# TECHNICAL SERVICE BULLETIN

Date: 7/17/95

merit industries, inc.

**Figure 1 - Securing Matrix Clamp to Microphone Board**

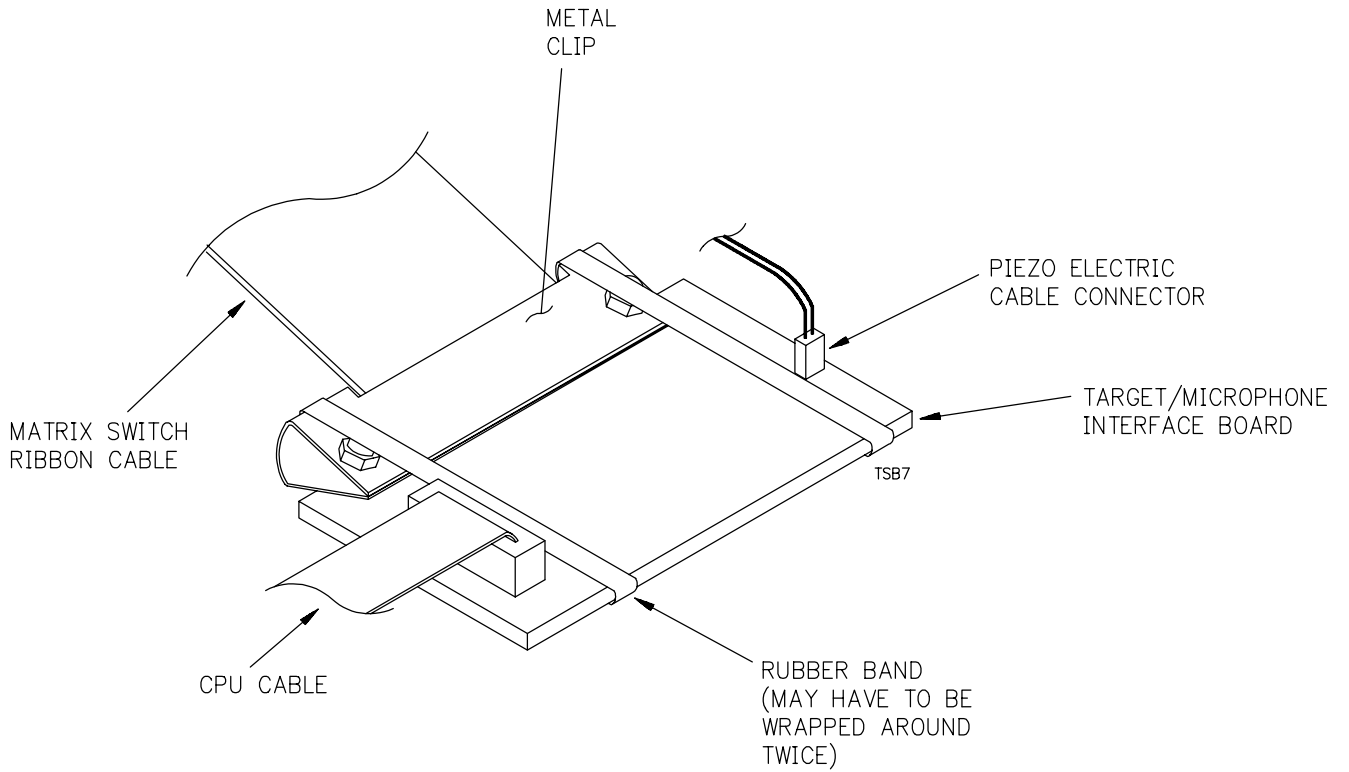
- Problem:** Target not scoring properly.
- Games affected:** All dart products.
- Symptoms:** Intermittent scoring.
- Cause A:** Bad connection from the matrix switch to the target/microphone interface board or from the microphone/target interface board to the CPU.
- Solution A:** Check the connection of the ribbon cable running from the target/microphone interface board and the CPU and secure the matrix switch cable connector to the target/microphone interface board using rubber bands.
- Cause B:** The existing clamp on the matrix switch cable connector is deforming the connector housing. (See Figure 2).
- Solution B** Replace the existing clamp with a new clamp of different design. To order a new clamp call Merit Customer Service, at 1-800-445-9353.

1. Open the target section to access the target/microphone interface board.
2. Disconnect from the target/microphone interface board, the Piezo electric sensor wires (the 2-pin connector) and the ribbon cable (that comes from the CPU).
3. Take the board off of the standoffs.
4. Place a rubber band around the board and the metal connector (one on each side), so that the connector is held firmly to the board. Be sure that the rubber bands rest on the metal of the connector and not against the cable itself. See Figure 1.
5. Put the board back on the standoffs and reconnect the cables to the board.

**Figure 2 - Example of "deformed" Clamp**

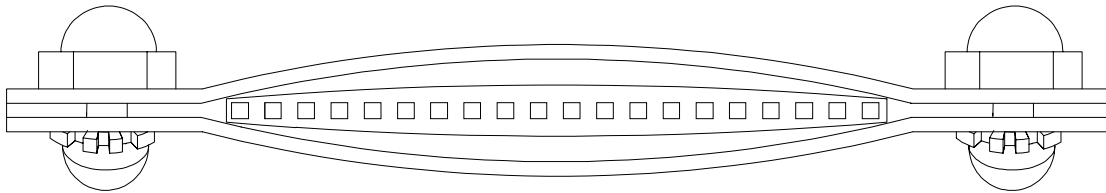
Overtightening of the matrix cable clamp makes the plastic connector housing deform, causing a loss of connection.
